Geochemical Consulting Services, LLC

July 28, 2008

I have reviewed documents associated with the Renewal of the Source Material License (No. SUA-1534) for Crow Butte, Nebraska and have found the applicant has not provided sufficient data to demonstrate proper development of (1) baseline water quality in the aquifer exemption zone and (2) excursion limits at monitoring wells.

Figure 1. Chart of aquifer exempt zone (i.e., zone surrounded by monitoring wells) and locations for baseline wells established with valid statistical methods.

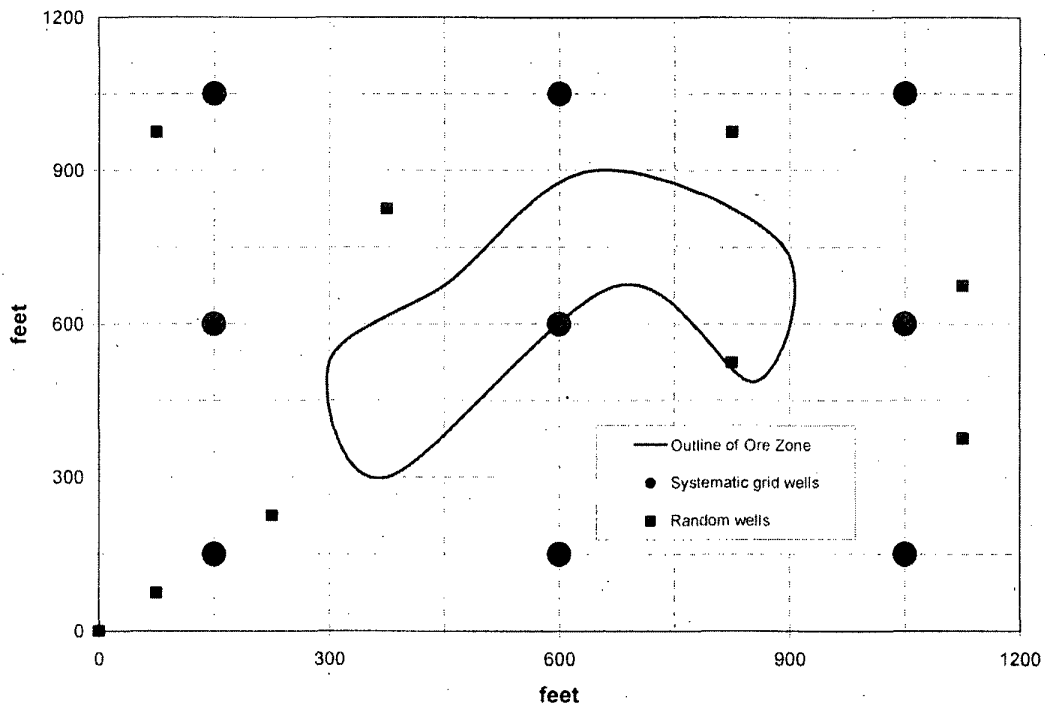
Figure 2.9-2 illustrates the proposed aquifer exemption zone around the ore bodies, and there is no statistical justification for the location of the baseline wells to validate that the results in Table 2.9-4 represent the water quality in the exempt zone. Note that the baseline wells in Figure 2.9-2 are clustered and not spread out over the entire exempt zone, and this violates statistical protocol. Within the aquifer exemption zone (i.e., the zone within the monitoring well ring), a systematic grid must be laid out to determine the location of the baseline water-quality wells. The density of nodes within the grid will be determined by the size of the area and the data quality objectives. Data quality objectives (EPA 2000a & 2000b) state the statistical confidence one wishes to have in the estimate of the mean (normal or log normal distribution) or median (no defined distribution) for the water-quality parameters. If a high level of confidence is required for an estimate of the mean or median, more baseline wells will be required.

Alternatively, we may elect to locate wells on the grid using a random number generator. In general, less wells are required if they are located randomly, and this is shown on Figure 1 as two random locations per quadrant. Free modeling software, developed by the Pacific Northwest National Laboratory for the Department of Energy (PNNL 2007), allows a large number of scenarios to be evaluated to determine the optimum data quality objectives and sampling approach for the stakeholders.

Figure 2. Cross section of an aquifer (20 to 90 feet) showing improper (Well 1) and proper (Well 2) sampling intervals to obtain a representative sample.

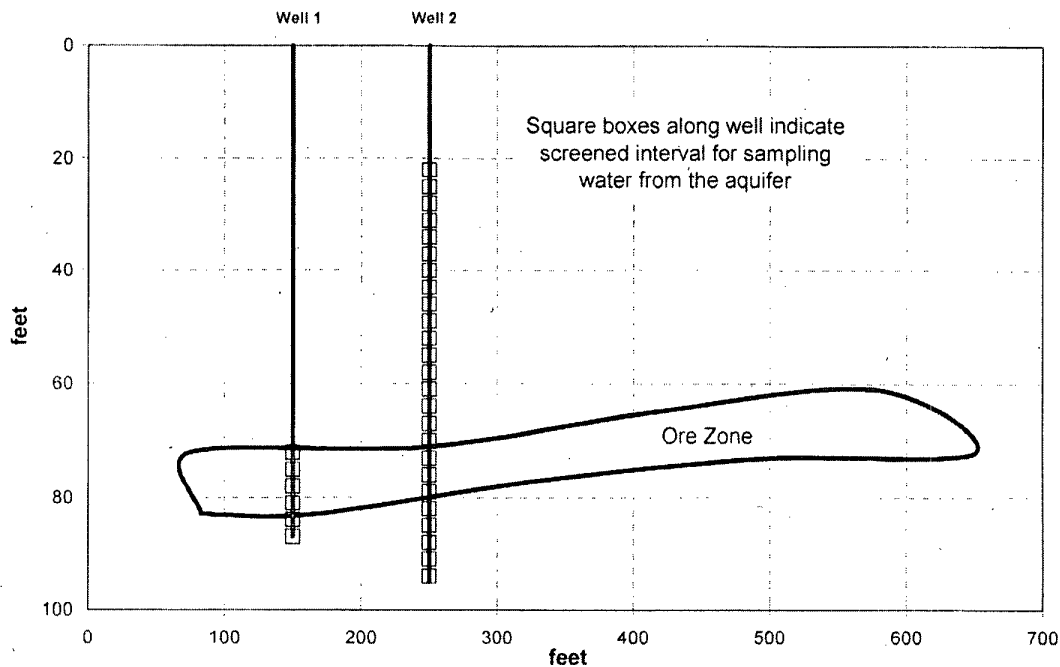
The well logs provided indicate the Chadron is approximately 50 to 80 feet thick through most of the mining area (Figures 2.6-4 through 2.6-11). The sampling interval for the baseline wells is 20 feet (Table 2.9-3), which does not represent the entire thickness of the aquifer. Figure 2 shows that a water sample obtained from Well 1, screened only in the ore zone, returns a biased sample that does not represent the water quality of the column of water at the given location. Well 2 (Figure 2) indicates the correct method for sampling the water, which requires that the entire thickness of the aquifer be screened to obtain a representative sample.

- 6) Figures 2.6-4 through 2.6-11 show the thickness of the Chadron to be 40 to 80-feet thick through most of the mine area. Therefore, it is inappropriate to use a screened interval of 20 feet to sample the groundwater from the ore zone (Table 2.9-3). The entire thickness of the aquifer must be sampled to obtain a representative sample.

Figure 3. Probability plot indicating that all data do not lie near or on a straight line, which rules out a normal or log normal distribution.

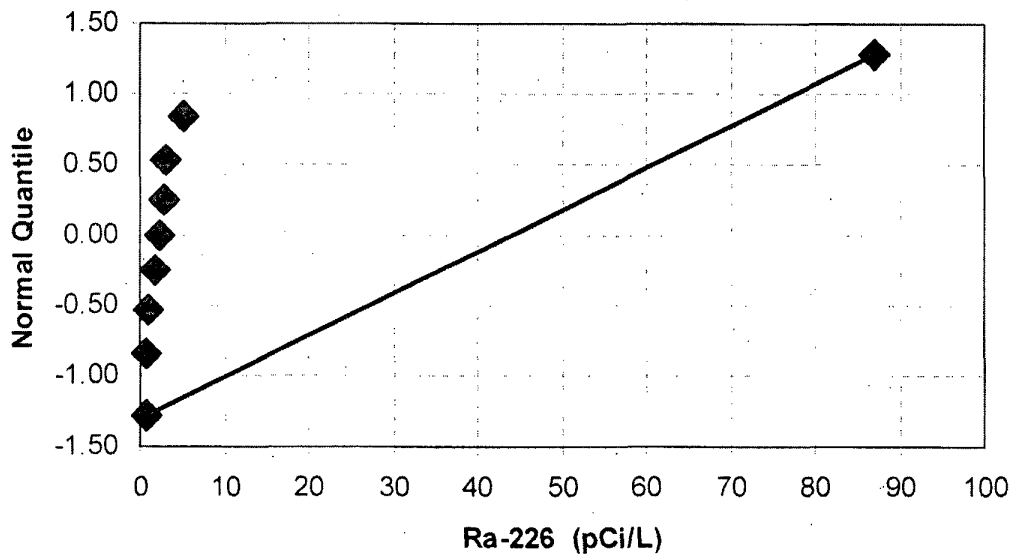
A probability plot of the data (Figure 3) and the results of the Shapiro-Wilk test confirm this. The normal-quantile values must fall on a straight line or the Shapiro-Wilk probability values must exceed 0.05 (at the 95 percent confidence level) for a normal or log normal distribution to be declared, which is clearly not the case. Therefore, the median, and not the mean, must be used to represent the central tendency of the data. Note that inappropriate use of the mean results in a high bias on the estimate of the baseline value for radium-226, which improperly elevates restoration clean-up levels and lowers the costs associated with the number of pore volumes needed to exchange to meet the clean-up levels.

Figure 4. Proper use of a control chart to determine lixiviant excursions.

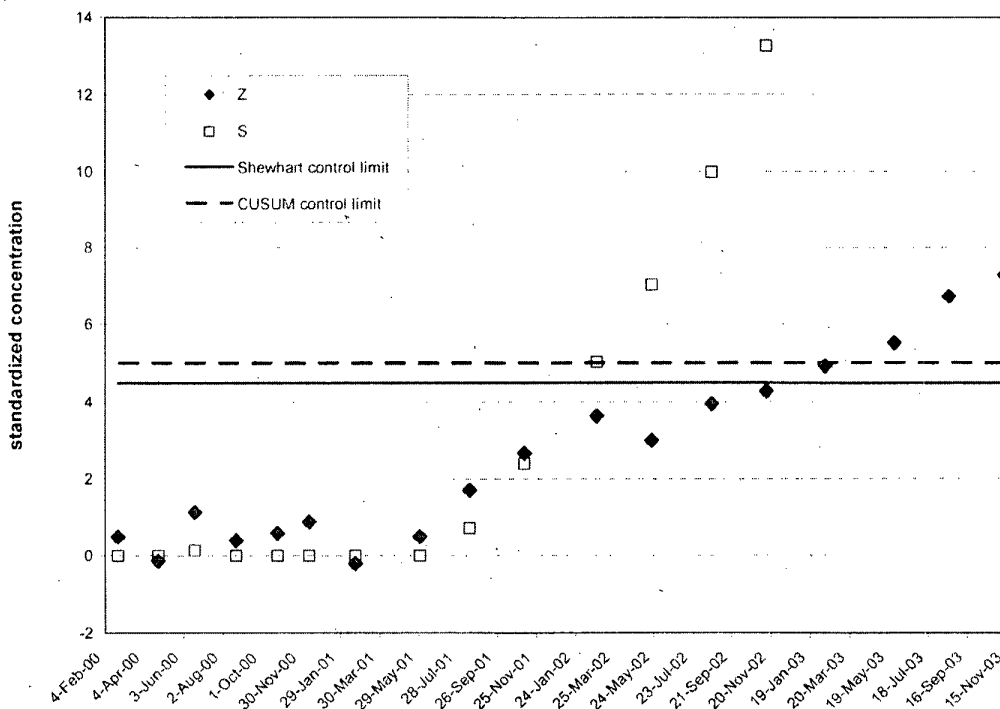
Figure 4 illustrates the importance of using the SCL and CUSUM for monitoring lixiviant excursion. The SCL (Z) and CUSUM (C) are plotted for an excursion parameter, a gradual increase in contamination exceeds the CUSUM limit in February of 2002, while the SCL limit is not exceeded until January of 2003. The SCL limit is similar to the CBR's use of 5 standard deviations above the mean for any one sampling event, although EPA recommends 4.5 standard deviations for any one sampling event. Using only the SCL limit allows contamination to migrate beyond the monitoring well for nearly a year before an excursion is declared. Therefore, if the CUSUM is not used with the SCL limit a gradual increase in contamination will not be detected and migration of diluted lixiviant will pass the monitoring well without corrective action.
